PUBLIC NOTICE
WOODLAND PARK PLANNING COMMISSION
Thursday, September 14, 2023, 6:30 P.M.
Council Chambers – 220 W. South Avenue

Planning Commission Staff Report Public Hearing September 14, 2023

Vacation: A request by applicant Derek Lutz (Farnsworth Group) and HSC Woodland Park, LLC (Property Owner) to consider a Conditional Use Permit and Site Plan Review, as well as a request to vacate the portion of Midland Avenue between Highway 67 and Burdette Street, for a proposed tire center store. The subject property is located at the NW corner of Midland Avenue and Highway 67 with a legal description of Lot 2, L. Clifford Filing No. 2, Woodland Park, Colorado and is zoned Service Commercial (SC). (QJ)

UTILITY PLAN

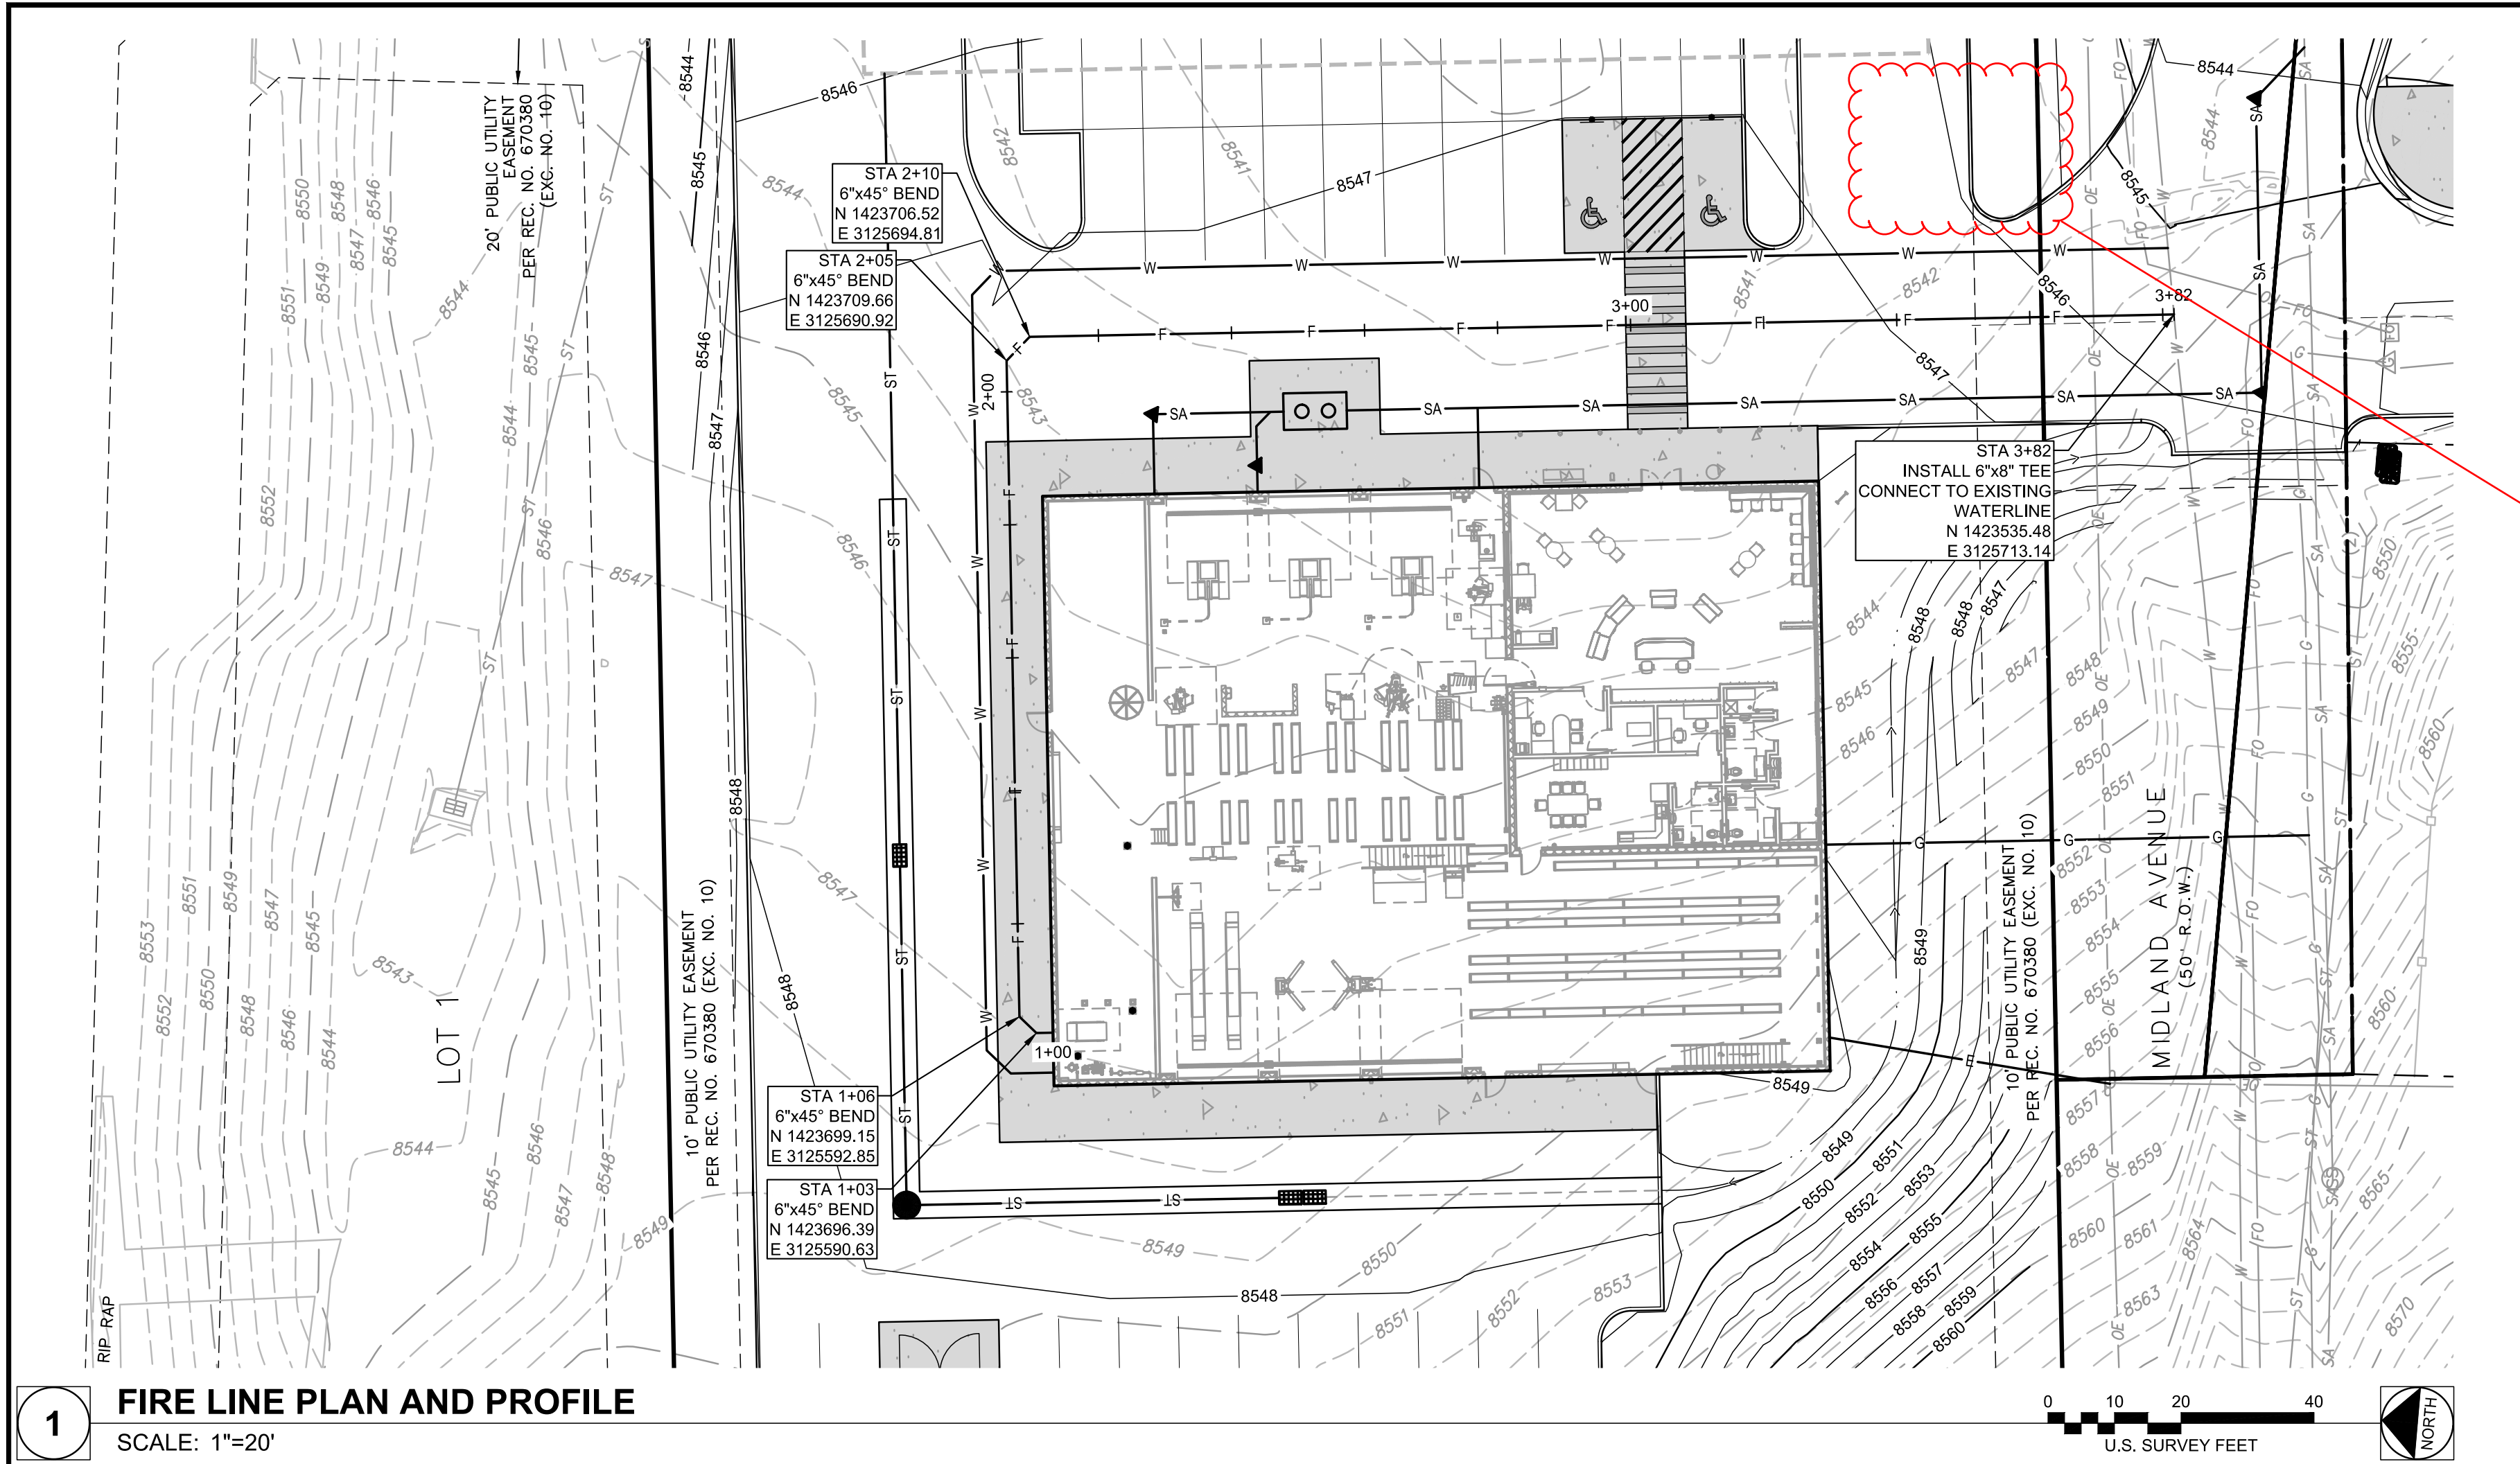
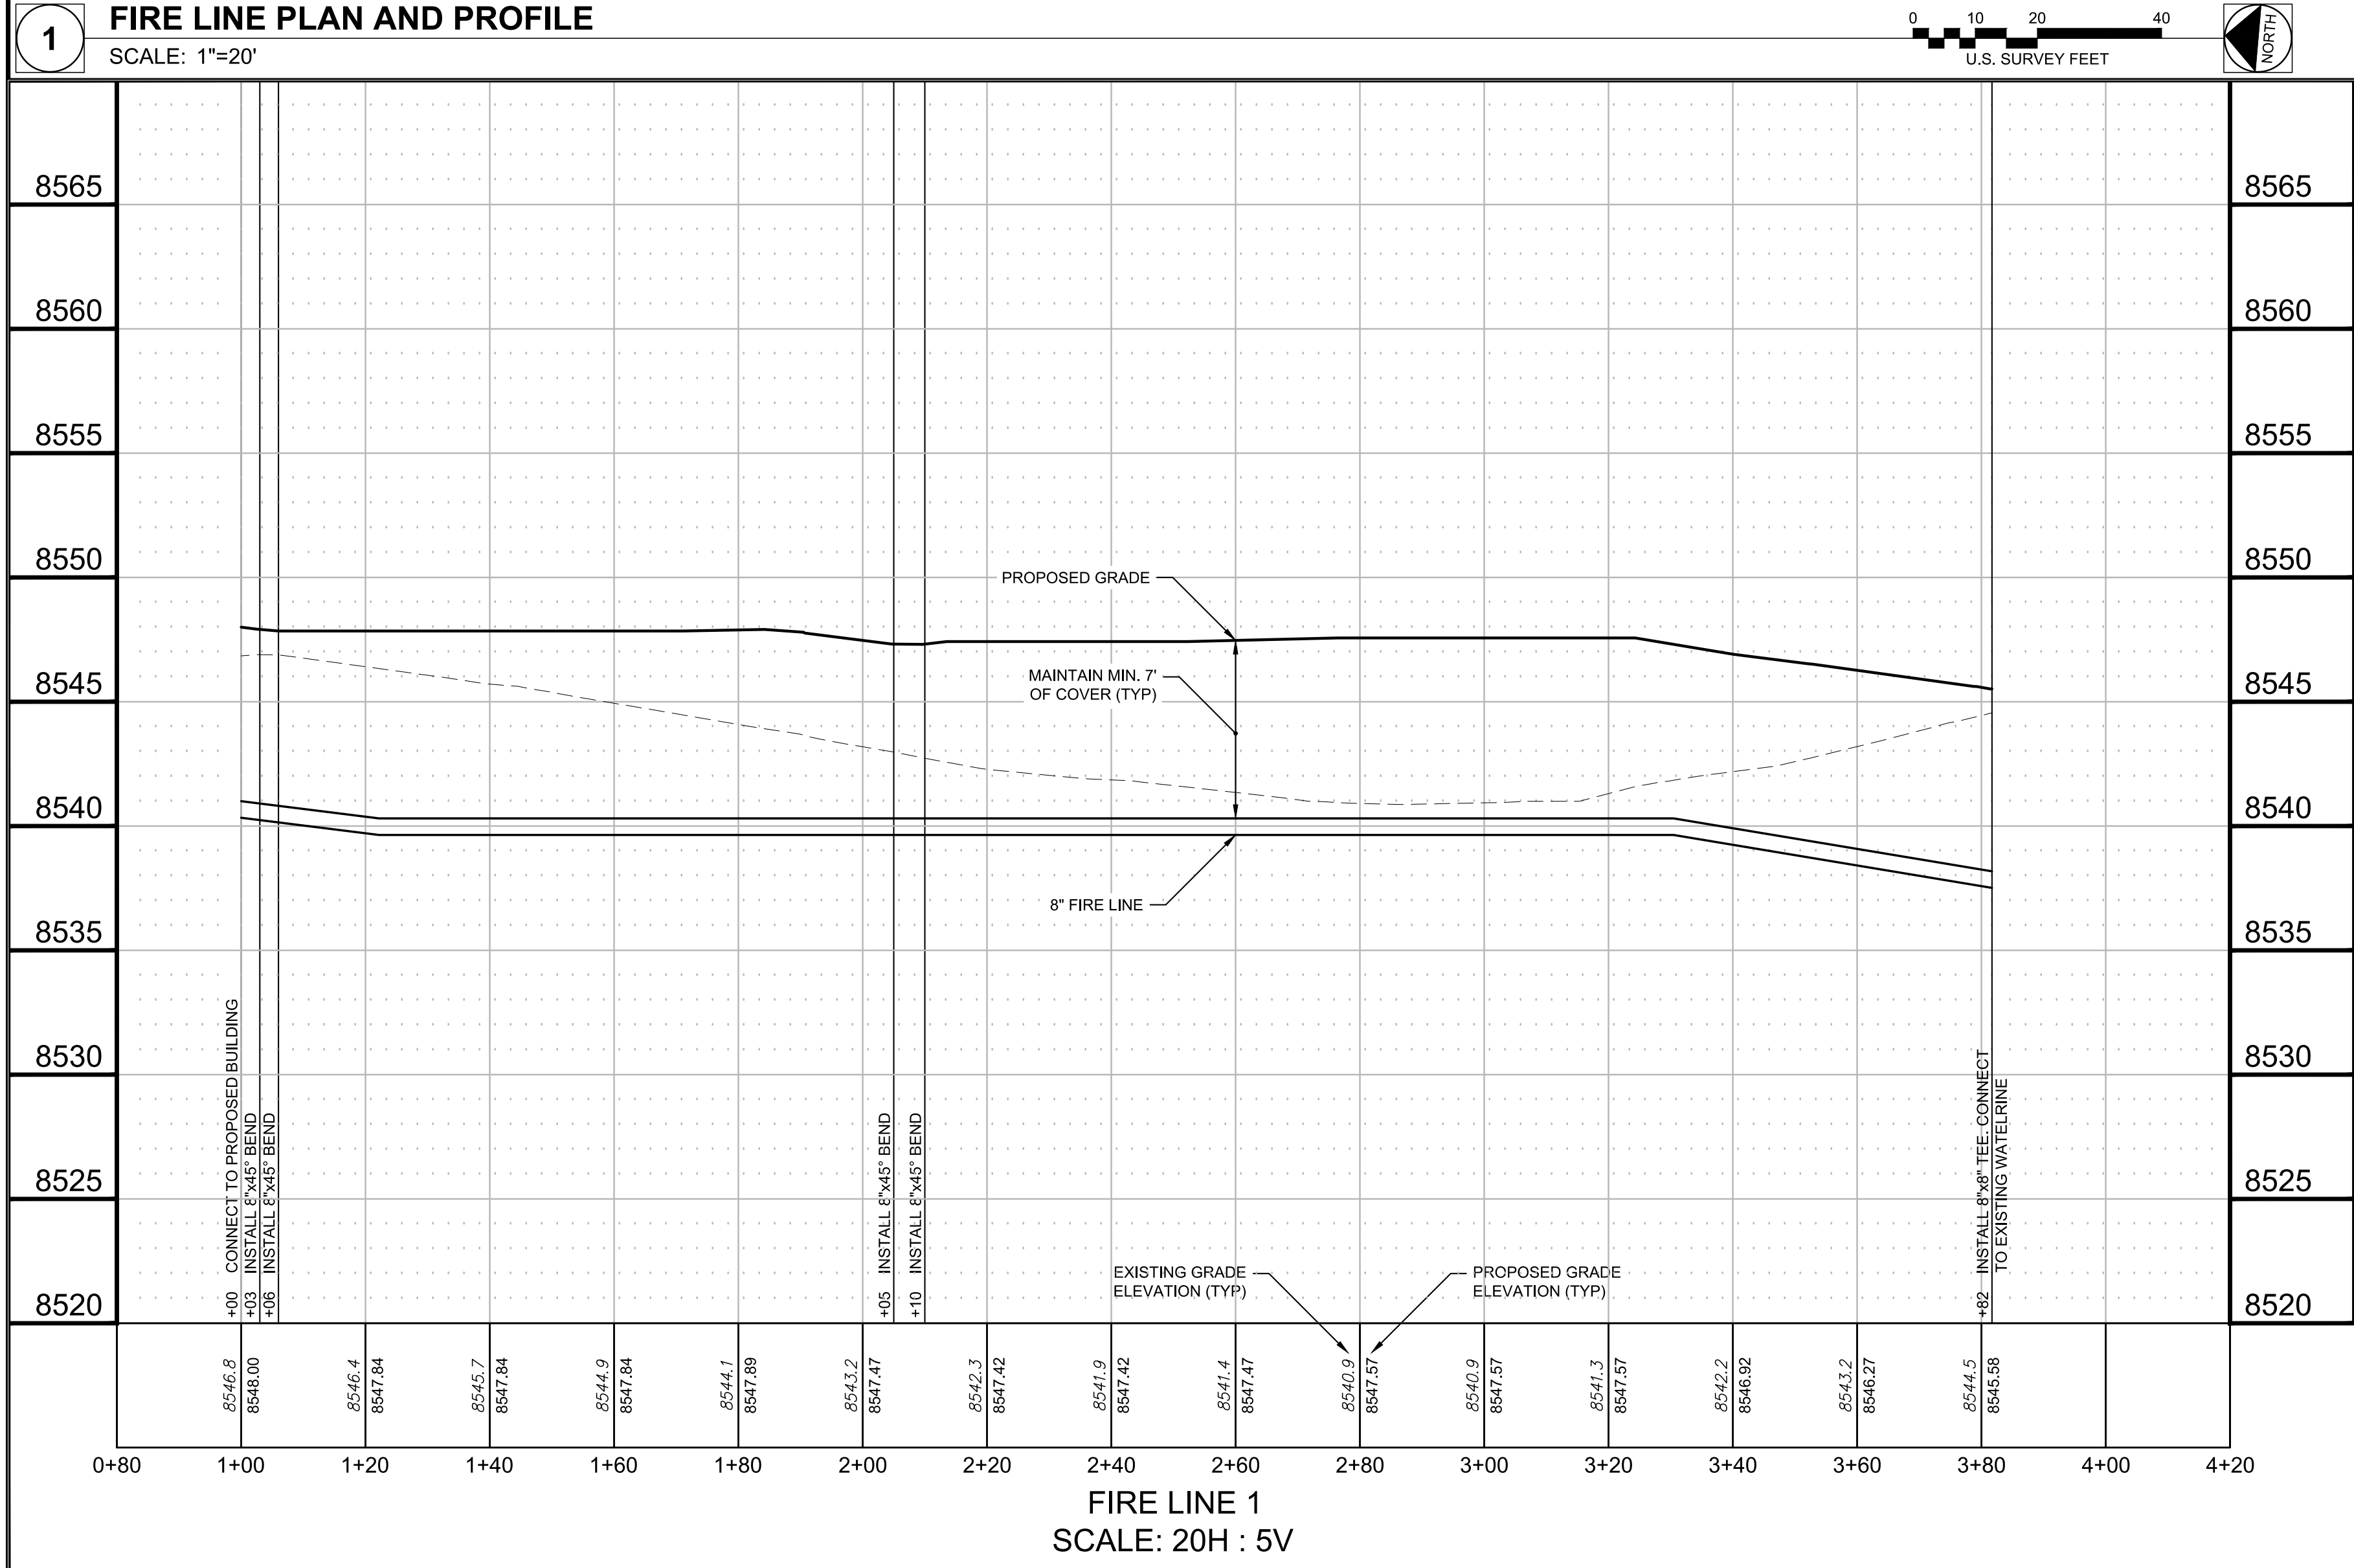
Nearest fire hydrant on east side of SH 67 will tapping on main be necessary?

CWP ES 2.1.3
2.1.3 FIRE HYDRANTS
Normally, the number of fire hydrants required and the spacing of hydrants shall be determined by the criteria of the latest edition of the City approved fire code. Whenever possible, fire hydrants shall be placed on one side of the street, rather than on alternating sides. Fire hydrant locations shall be selected to maximize visibility whenever reasonable. It is preferable to install fire hydrants at street intersections. Fire hydrants shall not be located within ten (10') feet of a curb inlet, gas meter, telephone. CITY OF WOODLAND PARK – Engineering Specifications 2-8
pedestal, or electric pedestal. Whenever possible, fire hydrants should be located at least 40 feet from building walls. The number and location of fire hydrants should be mutually agreed upon by the City Engineer or appointed representative and the Chief of the NETCFPD.
